Docket Number:	12-AFC-03
Project Title:	Redondo Beach Energy Project
TN #:	204742-1
Document Title:	City of Redondo Beach - Preliminary Staff Assessment Workshop -
Description:	Air Quality & Public Health Issues Presentation by James A. Westbrook, CCM, CPP
Filer:	Jon Welner
Organization:	Jeffer Mangels Butler & Mitchell LLP
Submitter Role:	Intervenor Representative
Submission Date:	5/26/2015 6:33:30 PM
Docketed Date:	5/27/2015

Redondo Beach Energy Project Preliminary Staff Assessment Workshop Air Quality & Public Health Issues

James A. Westbrook, CCM, CPP
May 20, 2015

LAX 5-year Wind Rose

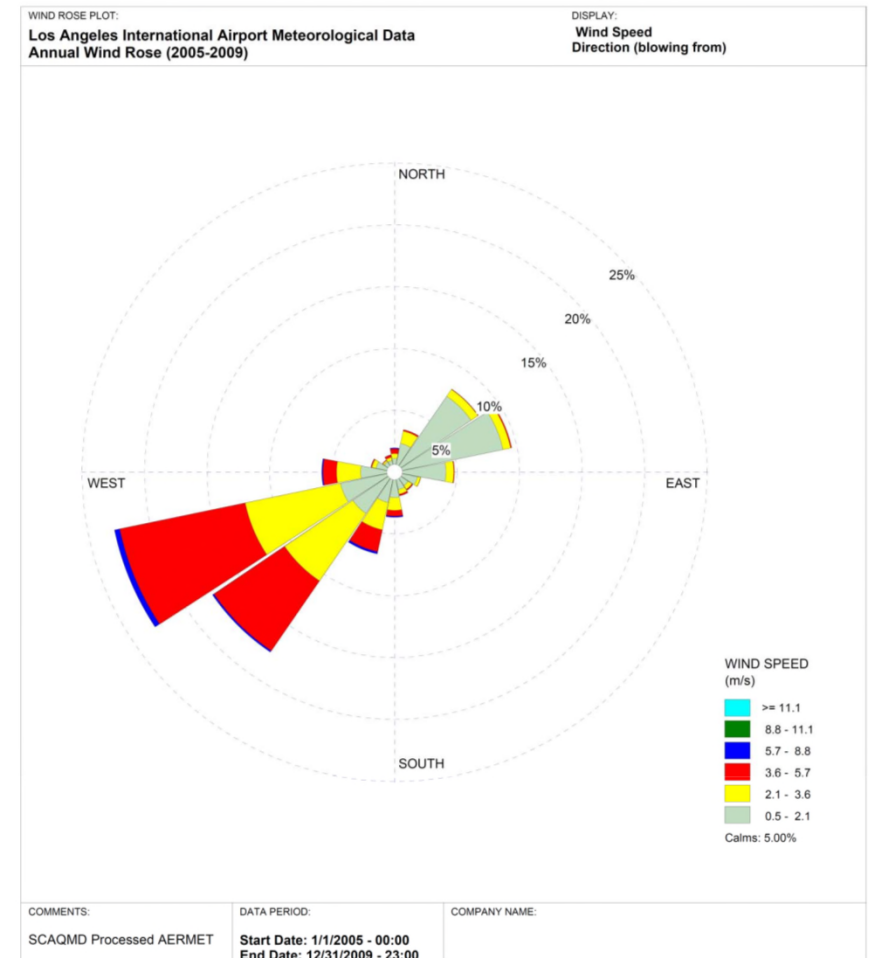
- AES' "standard" approach does not apply
- Unique, complicated scenario:
 - Shoreline location
 - Bluff to east; Palos Verdes peninsula
 - Lower power plant stacks
 - Atmospheric effects: Fumigation and Stagnation issues
 - Strong turbulent sea breezes
- Special impacts on nearby Bluff not studied
- Secondary fine PM formation not studied
- AERMOD and SCREEN3 models not acceptable for unique situation
- Edison decided against Redondo Power Plant repower in 1970s and 1980s

Offshore Pollution Flow & Return

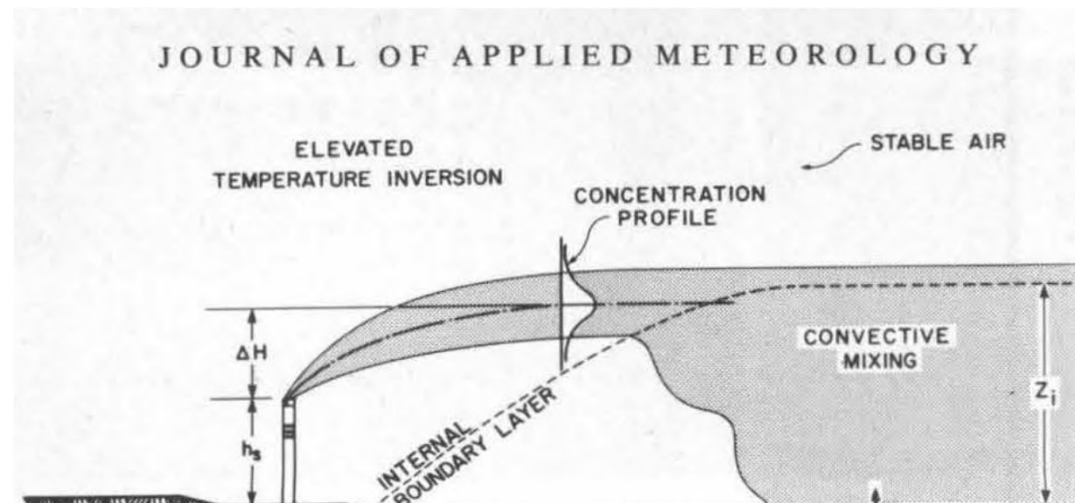
- Night: offshore pollution mixes to sea surface (fumigation) and may accumulate
- Day: Pollution may return to Redondo Beach
- Phenomenon not addressed by AES
- PM and air toxic impacts may be much greater than reported

Onshore Fumigation and Stagnation

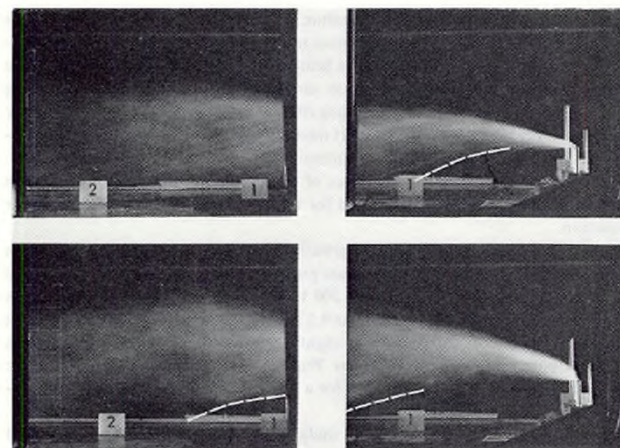
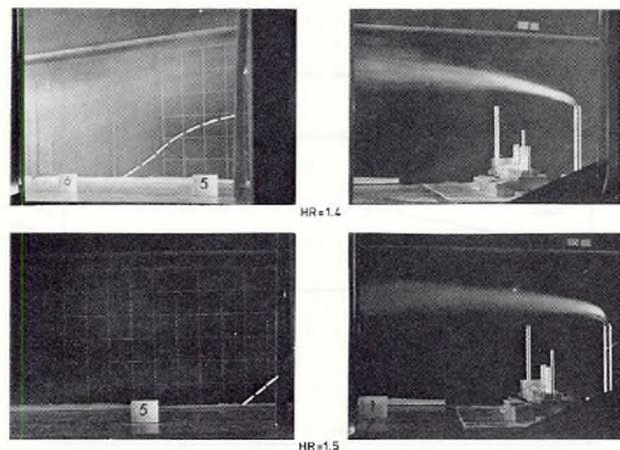
- Onshore fumigation study by AES not adequate
- PM not included
- SCREEN3 model a crude tool to address important impacts
- Stagnation events (low or calm winds) keep pollution in Redondo Beach
- 200-foot bluff one mile to east; 140-foot stacks
- Long-term PM and air toxic concentrations could be much higher

- Model all short-term and long-term impacts from direct and secondarily formed PM formation and air toxic emissions
- Consider special cases where plumes will interact with local atmospheric and terrain features
- Run the CALPUFF model, or consider more advanced work such as tracer studies
- Develop a meteorological network with multiple surface sites and local upper air data for at least one year
- Deny power plant licensing if unacceptable and unavoidable impacts
